STEERING CLUTCH REMOVAL ¹²

D8 Tractors (Series D and E)

HARDENED STEERING BOOSTER PUMP DRIVE GEARS ¹²

D8 Tractors (Series D and E), No. 583 Pipelayers

FIGURE 1—Slings for removal of steering clutch assemblies must be correctly attached as shown.

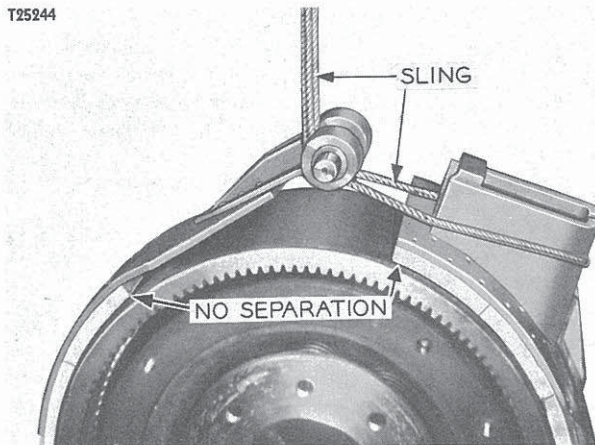
WHEN removing the steering clutches on D8 Tractors, care should be taken in attaching a sling to the brake bands to prevent bending of the bands away from the brake drum. Figure 1. Lifting a steering clutch from a tractor the wrong way tends to bend both ends of the brake band at the points

FIGURE 2—Incorrectly arranged slings can result in bending the brake bands away from the brake drums.

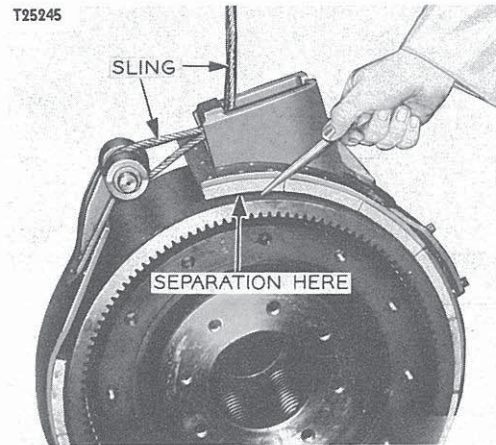
of suspension. Figure 2. This bending causes the bands to become out of round with respect to the brake drum and difficult to fit to the drum during assembly. With the band bent away from the drum at the ends, the brake linings do not uniformly contact the brake drum when the brakes are applied and reduce the effective braking surface area.

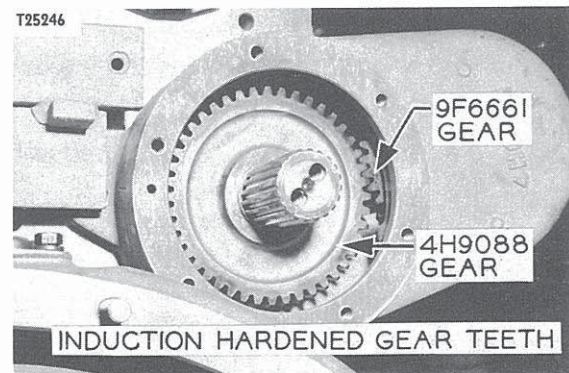
EFFECTIVE with D8 Tractors (Series D and E) 14A2429 and 15A1118 and No. 583 Pipelayer 16A200, the teeth on the steering clutch booster pump drive gears were induction hardened. The increased hardness of the gear teeth of the 4H9088 Gear on the rear power take-off shaft and the mating 9F6661 Gear provides greater resistance to wear and a longer service life. Part numbers of the gears have not changed.

Whenever the steering booster is reconditioned, it is suggested that the new, induction hardened 4H9088 and 9F6661 Gears be installed.
